# Access Compliance Report

## Public Rights-of-Way

### (Curb Ramps)

Intersection ID: 28112	Main Street: PROVIDENCE_RD	Cross Street: BELICOURT_DR	Location: SW
ADA ID: 4A78F50F5752	Ramp Type: Para	Initial Pass/Fail: Fail	Overall Compliance: No
Codes/Mitigation Info/Possible Solution		Field Measurements/Component Compliance	
Severity Score: 13.75

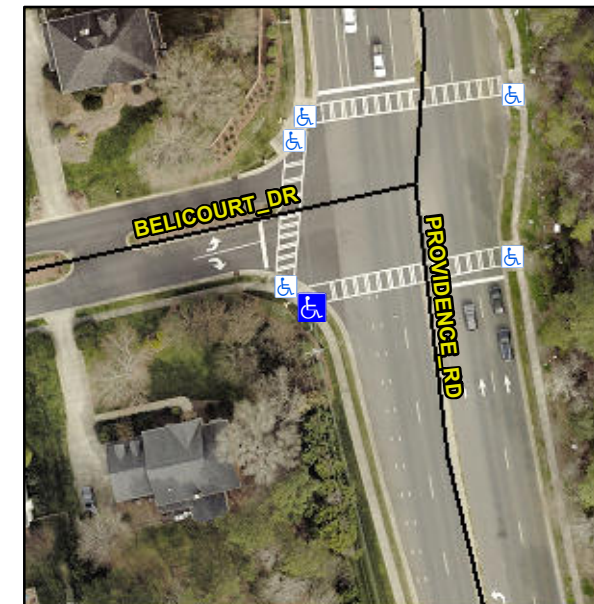
Surveyor Notes:

**LT RP < 5%**

PROW/ADA:

**R304.5.3, R304.3.2**

Possible Solutions:

**Remove & Replace Entire Ramp.**
